FLYING HORSE NORTH FILING NO. 1  
COUNTY OF EL PASO, STATE OF COLORADO  
CONSRTUCTION DRAWINGS  
DECEMBER 2017

FLYING HORSE NORTH FILING NO. 1  
STREET IMPROVEMENT PLAN  
STAGECOACH ROAD  
STA. 15+00.00 - STA. 30+00.00

FLYING HORSE NORTH FILING NO. 1			
STREET IMPROVEMENT PLAN			
LONGWALL COURT			
(STA. 11+50.00 - STA. 11+50.00)			
DESIGNED BY	PRA	SCALE	DATE 08-11-17
DRAWN BY	PRA	(H) 1"= 50'	SHEET 23 OF 58
CHECKED BY		(V) 1"= 5'	JOB NO. 1096.11

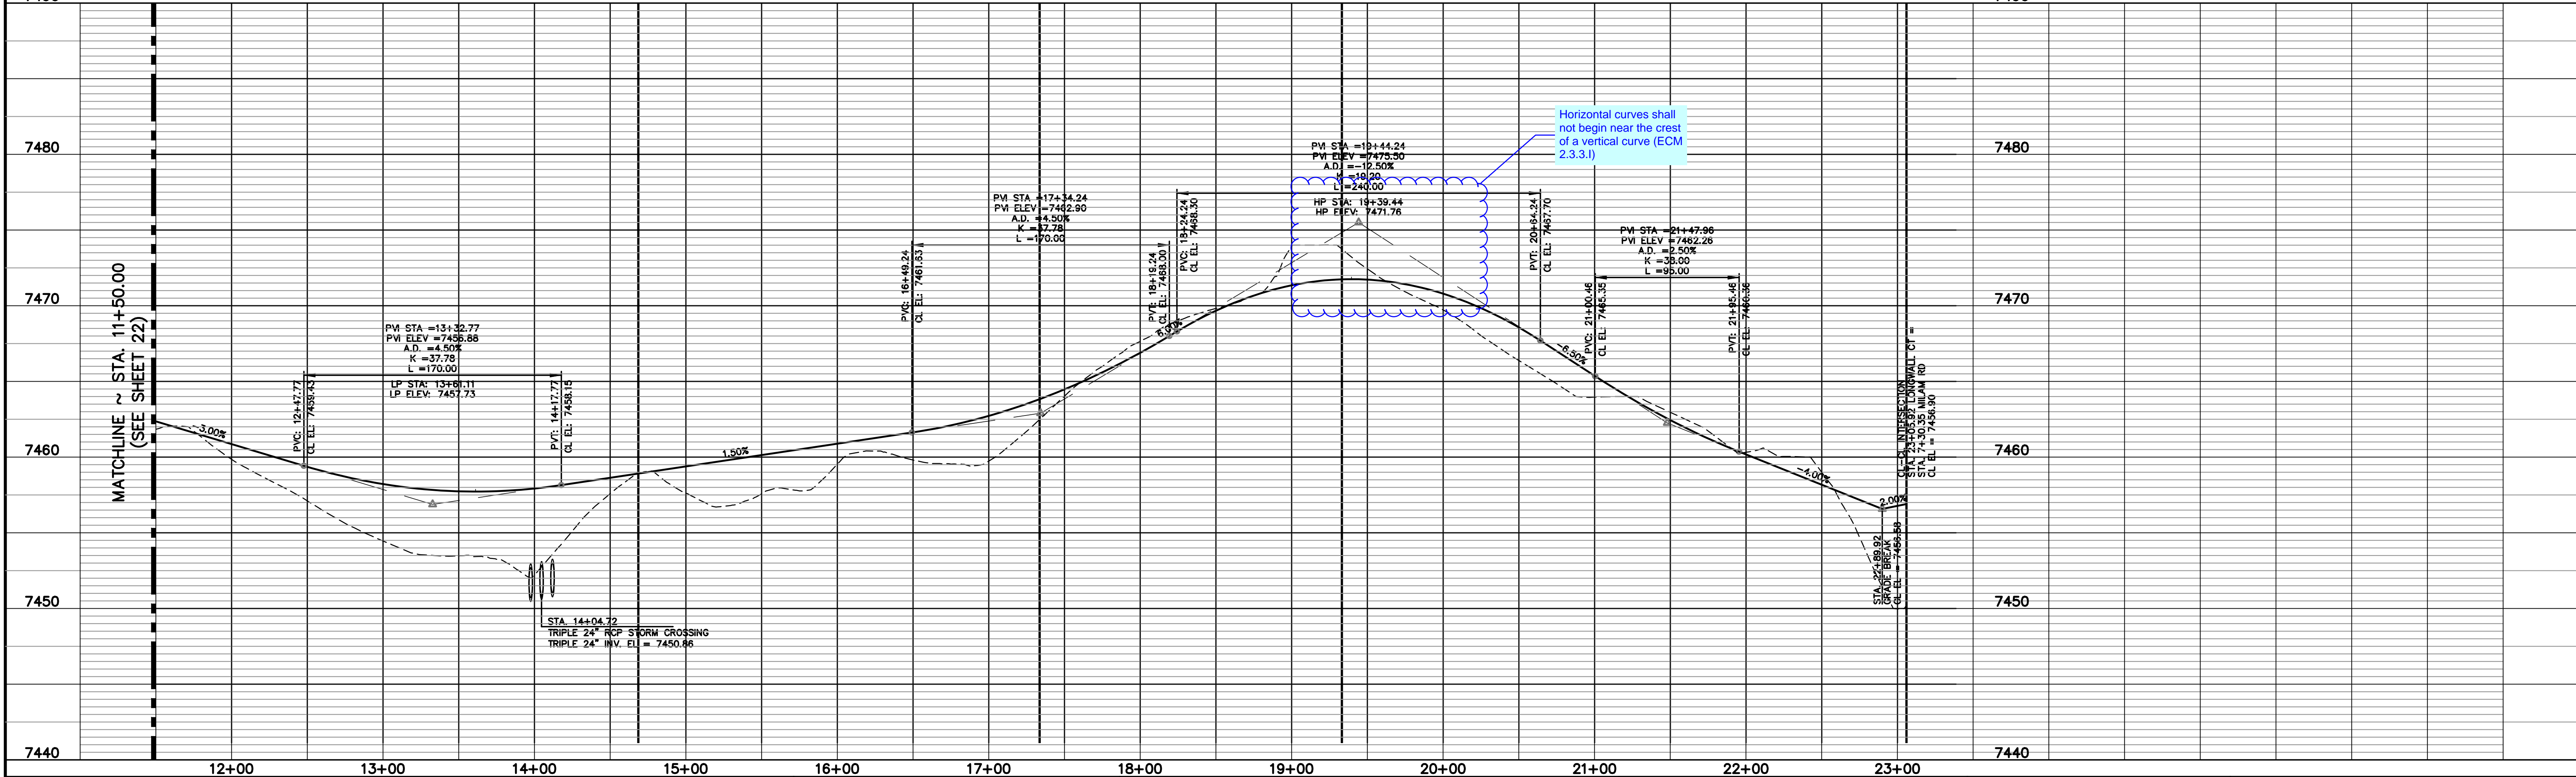
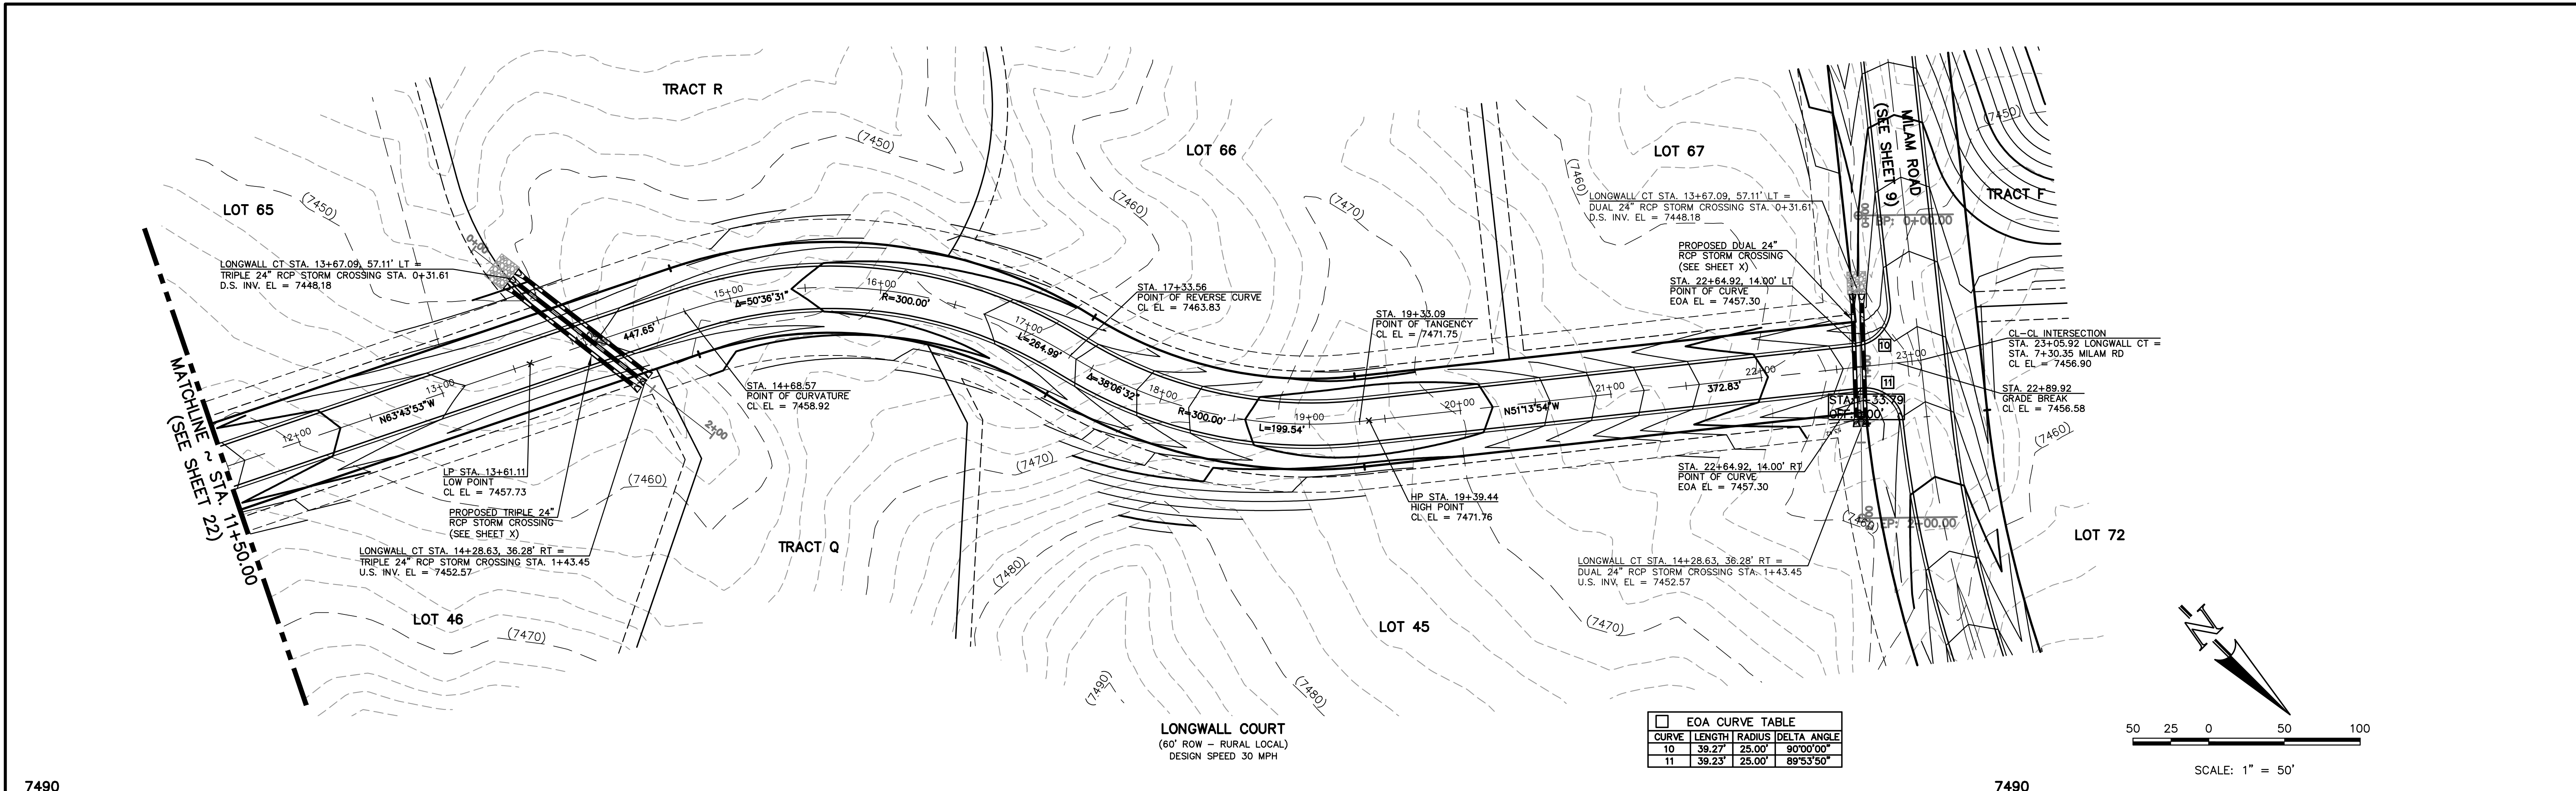
Provide a key map for the P&P

FLYING HORSE NORTH FILING NO. 1			
STREET IMPROVEMENT PLAN			
ROUNDABOUT 1			
DETAILED GRADING PLAN			
DESIGNED BY	PRA	SCALE	DATE 08-11-17
DRAWN BY	PRA	(H) 1"= 20'	SHEET 27 OF 58
CHECKED BY	(V) 1"= N/A	JOB NO.	1096.11

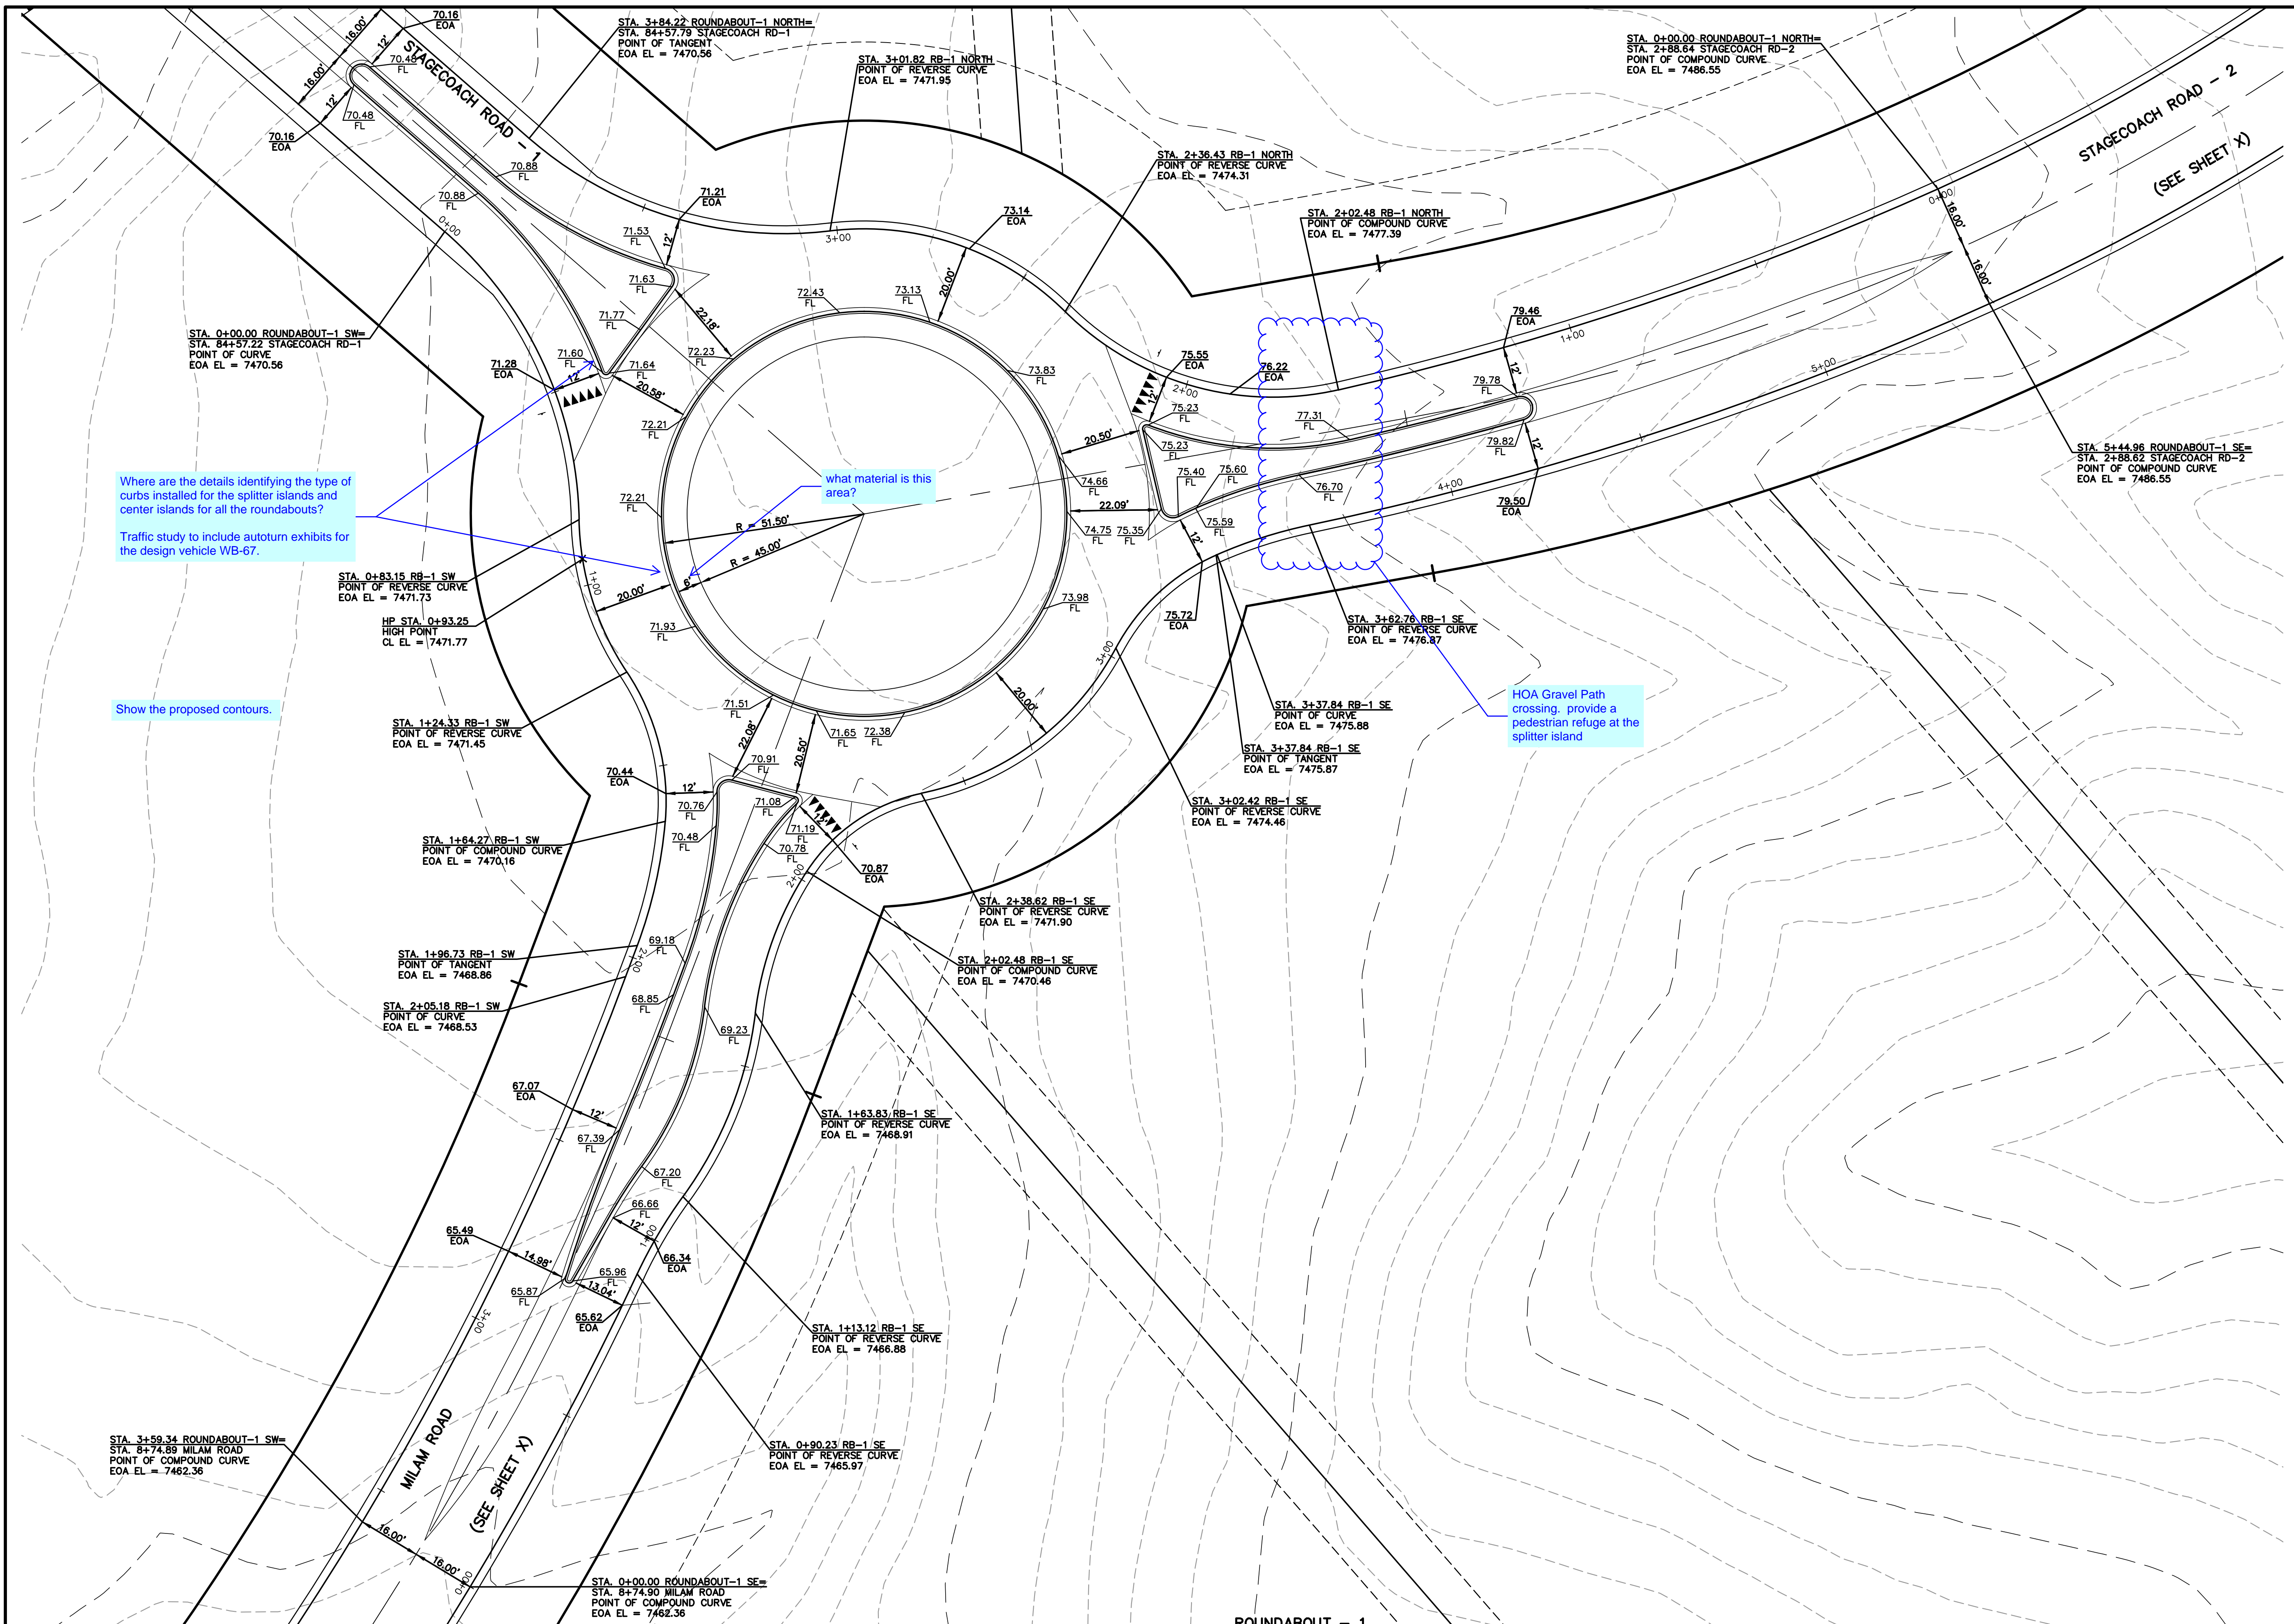
Where are the details identifying the type of curbs installed for the splitter islands and center islands for all the roundabouts?

Traffic study to include autoturn exhibits for the design vehicle WB-67.

Show the proposed contours.

FLYING HORSE NORTH FILING NO. 1  
STREET IMPROVEMENT PLAN  
STORM SEWER RCP CULVERT CROSSING PLAN

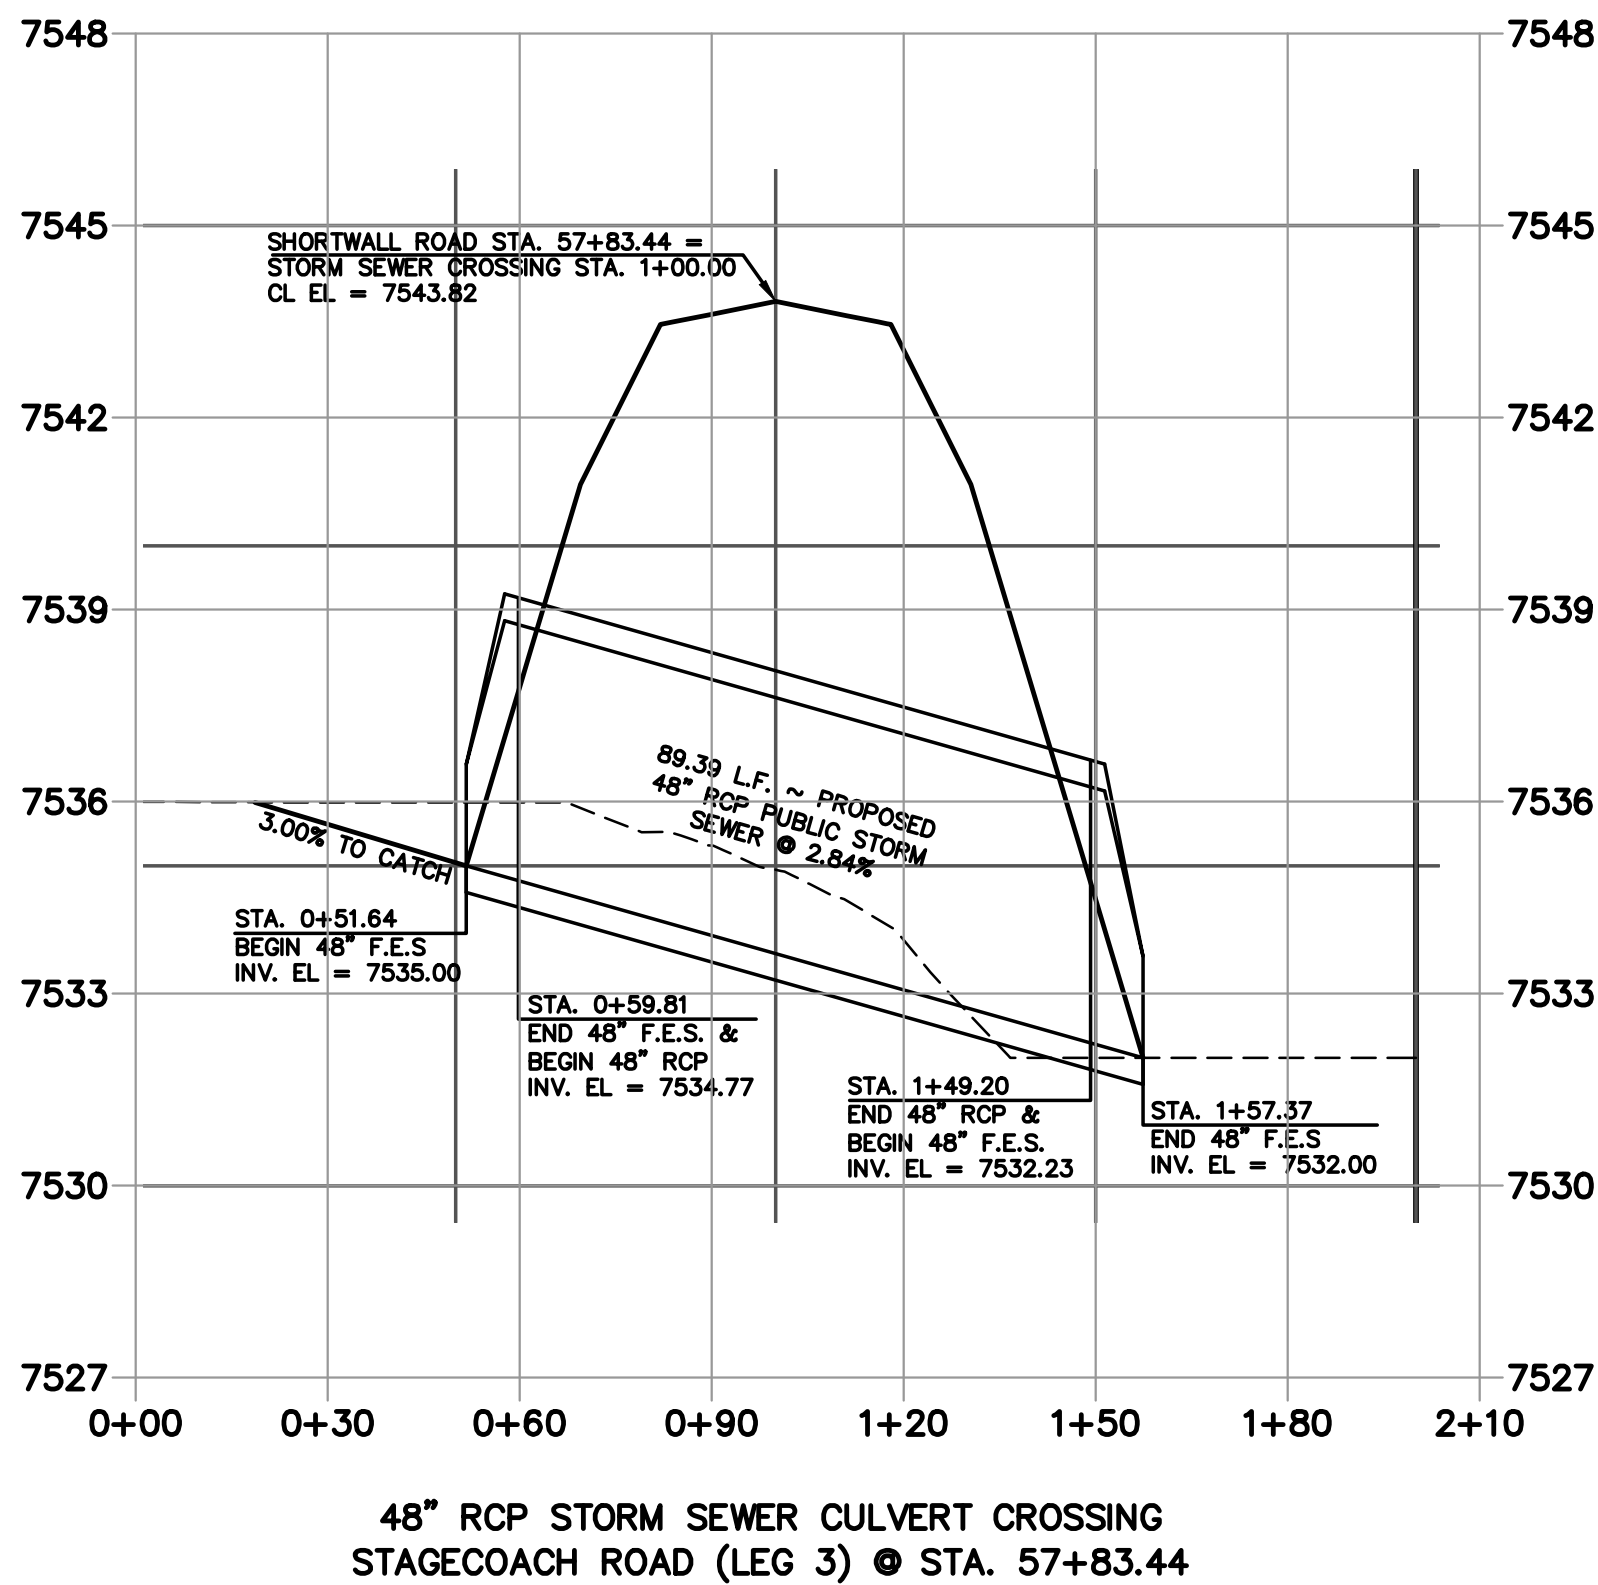
The street plans does not use this reference. Update plans for consistency.
